Second Regional Information Sharing on Pak Lay Prior Consultation Process

Second Draft Technical Review on Dam Safety

Mr. Palakorn Chanbanyong, Hydropower Development Specialist, MRC Secretariat

II. Main Review Findings – Project Layout

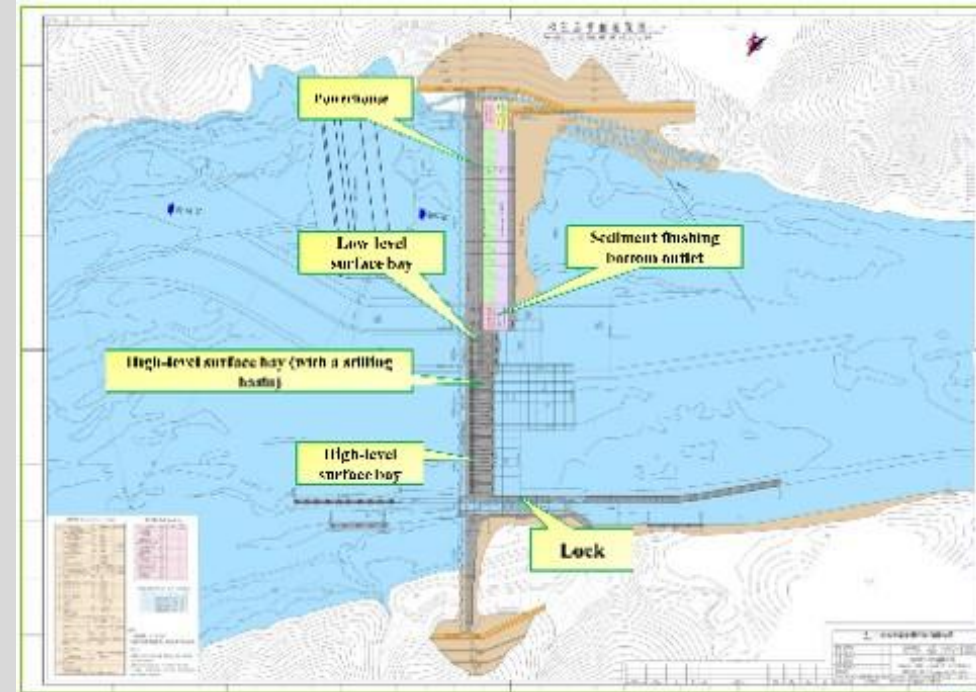
In general the overall layout of the proposed structures is adequate, however further clarification is sought in particular areas

- Important that **a final set of documents are prepared for the upper site and made available** → Avoid confusion in places and drawing
- The **feasibility study for Pak Lay should be updated to incorporate**, where relevant, the final design criteria and operational parameters for **Xayaburi HPP**.
- The Developer has used a **physical hydraulic model** to confirm the safe performance of the dam → **This report should be provided** as part of the prior consultation process.

Seismic

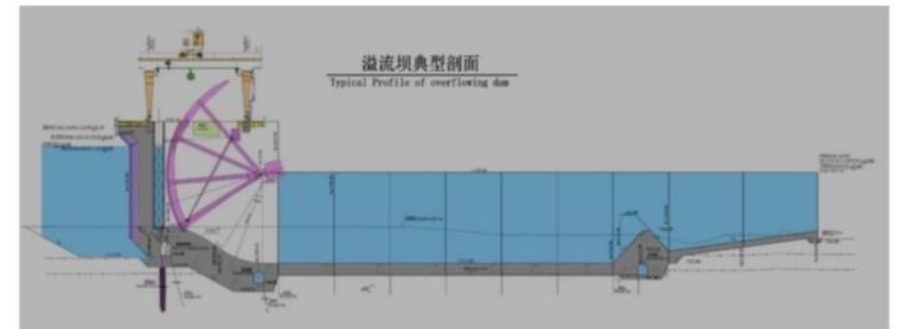
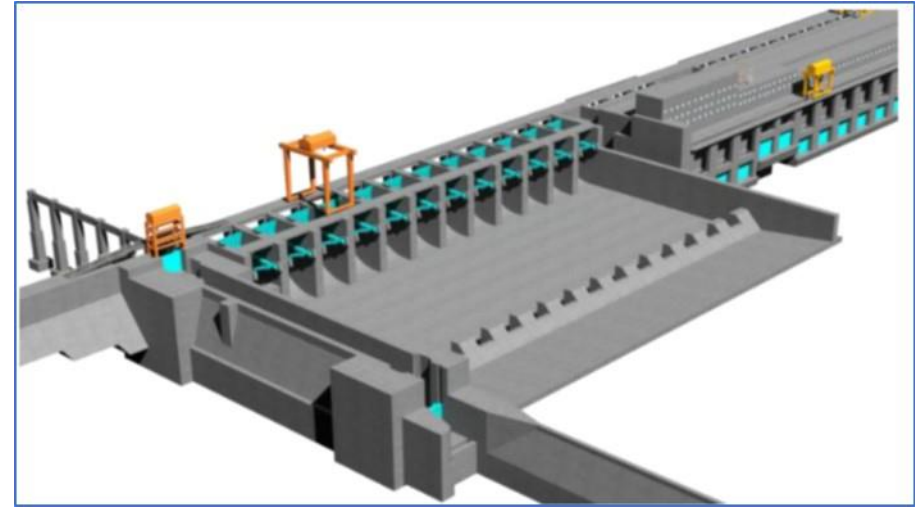
- Select **Return Period with a consistent approach** to the close MS projects
- The developer **should carry out a dam break consequence assessment** to provide further support to their selection of seismic design criteria.
- The developer **should provide a copy of the seismic hazard assessment** that supports the peak ground accelerations used in the design.
